Access Compliance Report

Public Rights-of-Way

(Curb Ramps)

Intersection ID: 46748	Main Street: SUPERIOR_ST	Cross Street: NORMANS_LANDING_DR	Location: NE
ADA ID: 368E53965E9A	Ramp Type: Perp	Initial Pass/Fail: Fail	Overall Compliance: No
Severity Score: 12.5			
Codes/Mitigation Info/Possible Solution		Field Measurements/Component Compliance

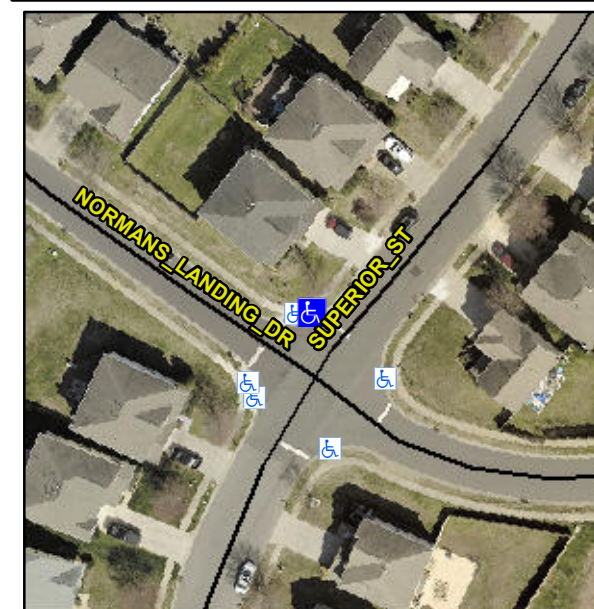
Not Found, R304.5.3

Compliance	Description	Data	Compliance	Description	Data
N/A	Ramp Length (in)	47.0	Yes	Ramp Slope (%)	5.5
Yes	Ramp Width (in)	60.0	No	Ramp XSlope (%)	6.9
N/A	Flare Type LT	N/A	N/A	Flare Type RT	N/A
N/A	Flare Slope LT (%)	N/A	N/A	Flare Slope RT (%)	N/A
N/A	Flare Traversable LT?	N/A	N/A	Flare Traversable RT?	N/A
N/A	Landing Length (in)	N/A	N/A	DWS Provided?	N/A
N/A	Landing Width (in)	N/A	N/A	DWS Contrast?	N/A
N/A	Landing Slope (%)	N/A	N/A	DWS Length (in)	N/A
N/A	Landing X Slope (%)	N/A	N/A	DWS Full Width?	N/A
N/A	Landing Curb? (Y/N)	N/A	N/A	DWS Offset (in)	N/A
N/A	Shared Landing?	N/A			
N/A	Gutter Ponding?	N/A	N/A	Gutter Slope (%)	N/A
N/A	Gutter Lip Ht (in)	N/A	N/A	Gutter X Slope (%)	N/A
N/A	Painted X Walk1?	No	N/A	Painted X Walk2?	N/A
	X Walk 1 Direction	To SE		X Walk 2 Direction	N/A
N/A	X Walk 1 Width (in)	N/A	N/A	X Walk 2 Width (in)	N/A
	X Walk 1 Slope (%)	1.8		X Walk 2 Slope (%)	N/A
	X Walk 1 X Slope (%)	2.6		X Walk 2 X Slope (%)	N/A

Remove & Replace Entire Ramp.
